# UNITED STATES PATENT AND TRADEMARK OFFICE

APPLICATION NO.	FILING DATE	FIRST NAMED INVENTOR	ATTORNEY DOCKET NO.	CONFIRMATION NO.
10/522,931	01/24/2005	Alfred Losch	71657	6637

<b>Office Action Summary</b>	<b>Application No.</b> 10/522,931	<b>Applicant(s)</b> LOSCH, ALFRED	
	<b>Examiner</b> Nahid Amiri	<b>Art Unit</b> 3679

## DETAILED ACTION

FIG. 3

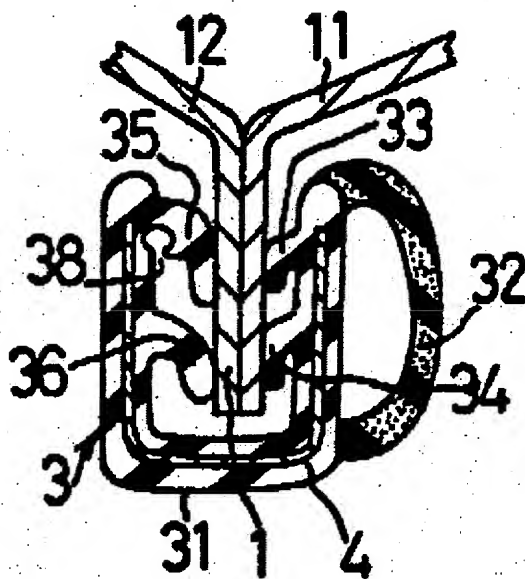
With respect to claim 1, Hayashi et al. disclose a connection (Fig. 3) of outer and inner sheets (11, 12) each sheet (11, 12), having an edge, wherein the edges of the sheets (11, 12) have at least partially planar contact and can be detachably connected with one another, the connection comprising flanges associated with the areas of the edges of said sheets (11, 12) lying on top of each other, wherein the flanges are bent in the same direction and a detachable connection of the sheets (11, 12) by means of a clamping strip (3).

With respect to claim 2, Hayashi et al. disclose (Fig. 3) that the clamping strip (3) has an at least partly U-shaped design.

With respect to claim 3, Hayashi et al. disclose (Fig. 3, column 3, lines 8-12) that the clamping strip consists of a plastic.

With respect to claim 7, Hayashi et al. disclose that the connection (Fig. 3) further includes a joint sealing (32) integrated in the clamping strip (3).

With respect to claim 8-9, Hayashi et al. disclose (Fig. 3) that the clamping strip (3) capable of being designed at the same time as an outer sealing (32); and wherein the clamping strip (3) extends fully over the circumference of the edges of the sheet (11, 12).

FIG. 10

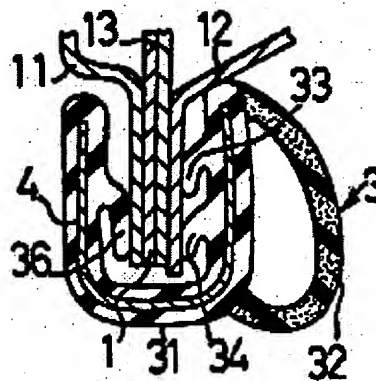
With respect to claim 4, Hayashi et al. disclose (Fig. 10) that the clamping strip (3) has a metal core (4).

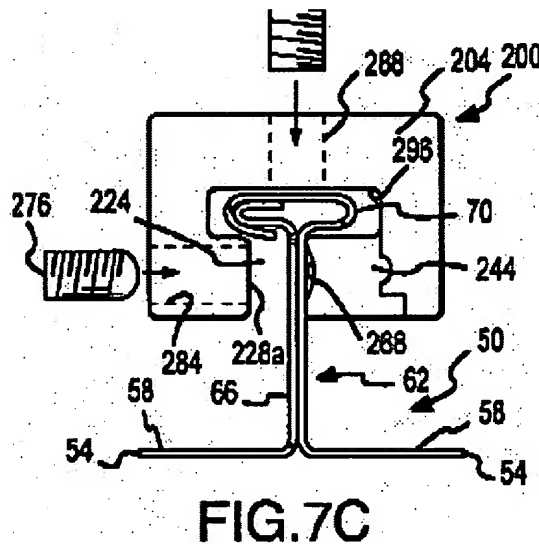
With respect to claims 1 and 10, Haddock disclose a connection (Fig. 7C) of outer and inner sheets (54), each sheet (54) having an edge, wherein the edges of the sheets (54) have at least partially planar contact and can be detachably connected with one another, the connection comprising flanges (66) associated with the areas of the edges of said sheets (54) lying on top of each other that are bent in the same direction and a detachable connection of the sheets (54) by means of a screw connection (276), and a clamping strip (200) providing a detachable connection of the sheets (54) at the flanges.

With respect to claims 2 and 11, Haddock disclose (Fig. 7C) that the clamping strip (200) has an at least partly U-shaped design.

With respect to claims 5 and 6, Haddock discloses (Fig. 7C) that the clamping strip (200) and the edges (66) of the sheets (54) are connected to one another by means of the screw connection (276).

With respect to claims 8 and 9, Haddock disclose (Fig. 7C) that the clamping strip (200) capable of being designed at the same time as a cover strip (not shown); and wherein the clamping strip (200) extends fully over the circumference of the edges of the sheet (54).

With respect to claim 15, Haddock discloses a connection (Fig. 7C) further having a joint sealing (constituted by the concave portion of the inner sidewall of the clamp 200) connected together with the clamping strip (200) and the edges (66) of the sheets (54) to be connected by means of the screw (276).

With respect to claim 16, Haddock discloses (Fig. 7C) that a joint sealing (constituted by the concave portion of the inner sidewall of the clamp 200) integrated in the clamping strip (200).

With respect to claims 17 and 18, Haddock discloses (Fig. 7C) that the clamping strip (200) capable of being designed at the same time as a cover strip (not shown); and wherein the clamping strip (200) extends fully over the circumference of the edges of the sheet (54).
